Groundwater Application Review Summary Form

Application # G- 18783

MEMO

To: Kristopher Byrd, Well Construction and Compliance Section Manager
From: Joel Jeffery, Well Construction Program Coordinator
Subject: Review of Water Right Application G-18783
Date: April 16, 2019

Hydrographs

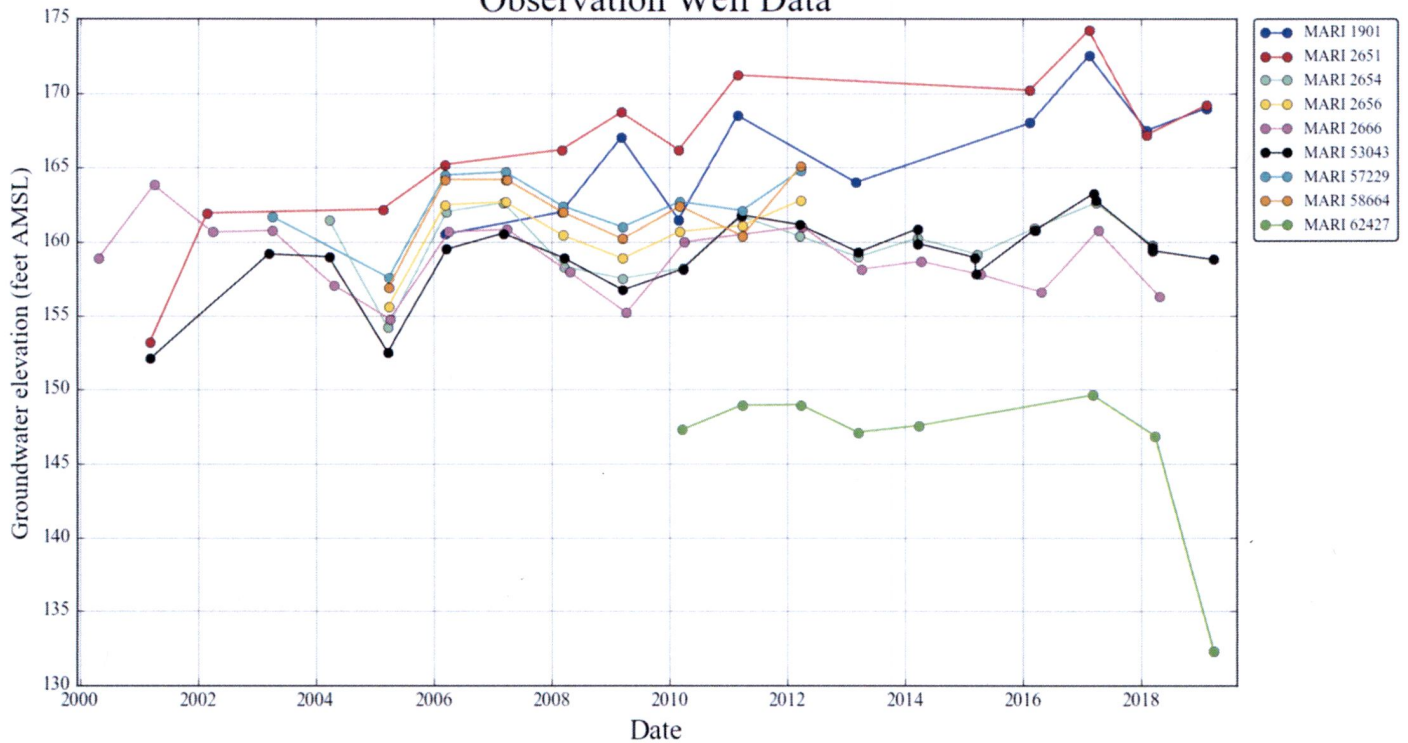
Recent water levels for nearby observation wells do not indicate persistent or widespread declines in the Willamette Aquifer in this area (see Hydrograph, attached). Reported yields for nearby wells range from 20 to 700 gpm, with a median yield of 150 gpm. Although the requested rate under this application (1.114 cfs / 500 gpm) combined with the authorized rate under Certificate 89507 (0.48 cfs / ~215 gpm) would exceed the reported yield of both MARI 2625 (30 gpm) and MARI 2614 (500 gpm) and is significantly higher than the median yield in this area, it would not be much outside the range of reported yields. Based on the preponderance of evidence, it cannot be stated that the proposed use would exceed available capacity of the groundwater resource in this area.

Thisis Drawdown Analysis

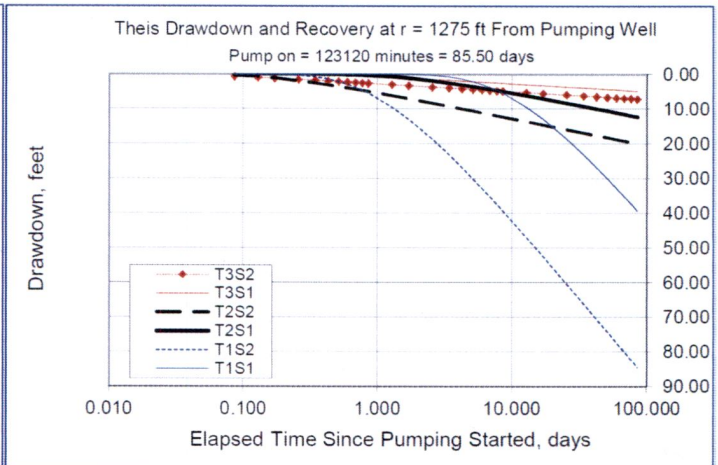
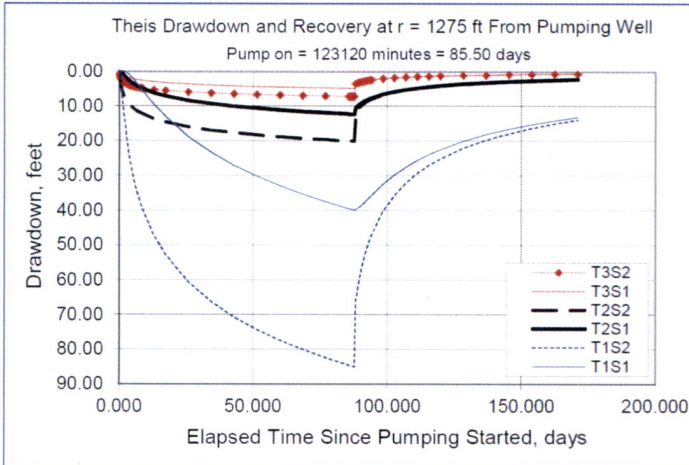
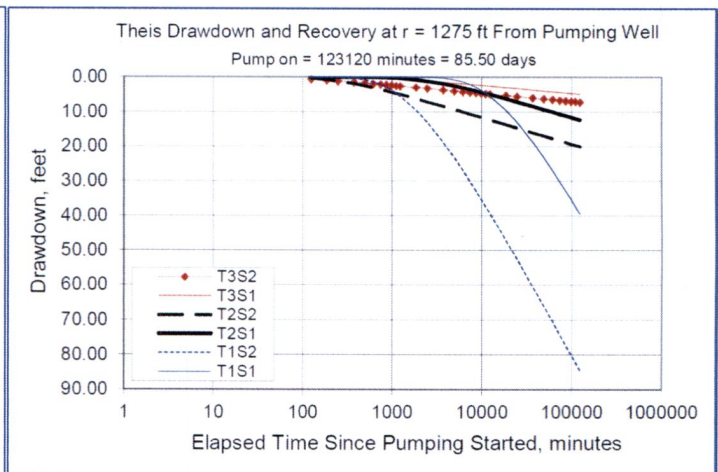
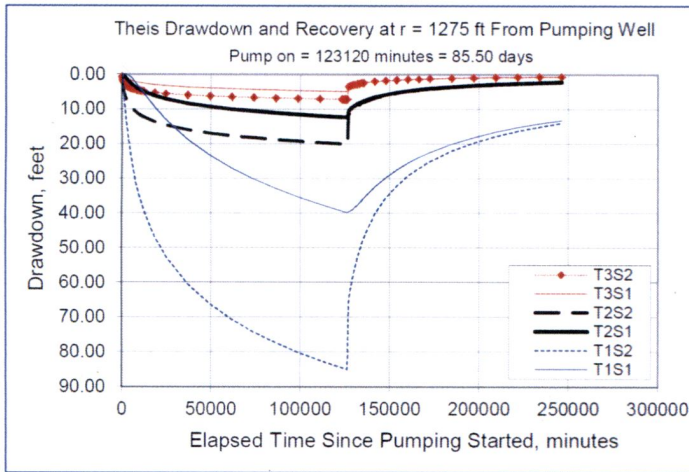
Potential injury to other nearby groundwater rights was analyzed using the Theis equation for drawdown in a confined aquifer (Theis, 1935). Hydraulic parameters used for the analysis were derived from regional data and studies (Pumping Test Reports, Conlon et al., 2003, 2005; Iverson, 2002; McFarland and Morgan, 1996; Woodward et al., 1998) or are within a typical range of values for the parameter within the hydrogeologic regime (Freeze and Cherry, 1979; Domenico and Mifflin, 1965). The nearest known groundwater right to the proposed POA is MARI 2633, approximately 1,275 ft southeast of POA 2 (MARI 2614) (see Well Location Map, attached). Assuming a continuous pumping rate of 1.594 cfs (~715 gpm) for 85.5 days (the most conservative pumping scenario) under the most likely hydraulic parameters, results using the Theis equation indicate that pumping of MARI 2614 is not anticipated to affect another groundwater right such that said right would not be able to divert water to which it is legally entitled (see Theis Drawdown Analysis, attached).

Stream Depletion Analysis: POA 2 – SW 1

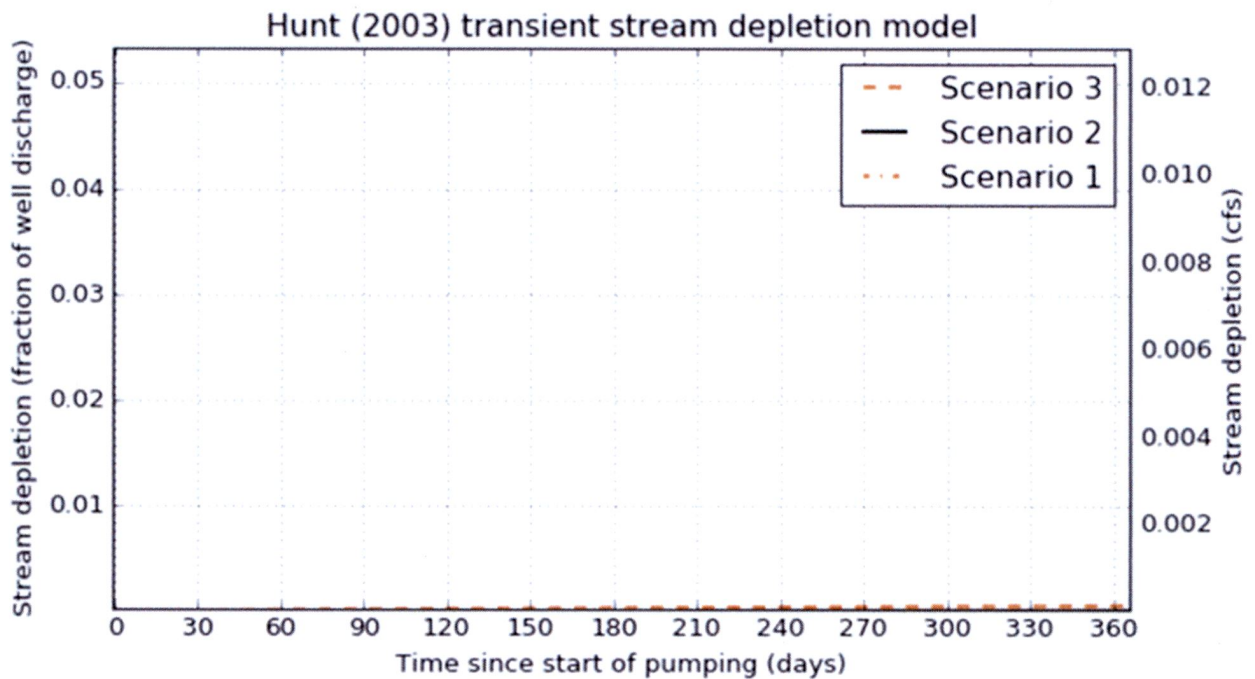
Basis for impact evaluation: Stream depletion of SW 1 due to pumping of POA 2 (MARI 2614) – being the nearest proposed POA to SW 1 – was evaluated using the Hunt 2003 analytical stream depletion model (Hunt, 2003). Hydraulic parameters used for the analysis were derived from regional data and studies (Pumping Test Reports, Conlon et al., 2003, 2005; Iverson, 2002; McFarland and Morgan, 1996; Woodward et al., 1998) or are within a typical range of values for the parameter within the hydrogeologic regime (Freeze and Cherry, 1979; Domenico and Mifflin, 1965). The pumping rate was pro-rated based on the total permissible volume and season of use proposed in this application and authorized in Certificate 89507.

Based on the Hunt 2003 model results, the depletion of SW 1 due to pumping of POA 2 (MARI 2614) within one year of pumping is anticipated to be much less than 1 percent of the proposed pumping rate. The anticipated depletion is also much less than 1 percent of the stream discharge that is equaled or exceeded 80 percent of the time as estimated for the PUDDING R > MOLALLA R – AB MILL CR WAB, which encompasses SW 1 (Sam Brown Creek) (see Water Availability Tables, attached). The low proportional rate of depletion is likely due to the significant distance between the proposed POA and SW 1 as well as the substantial quantity of low-permeability, fine-grained sediment underlying the stream channel.
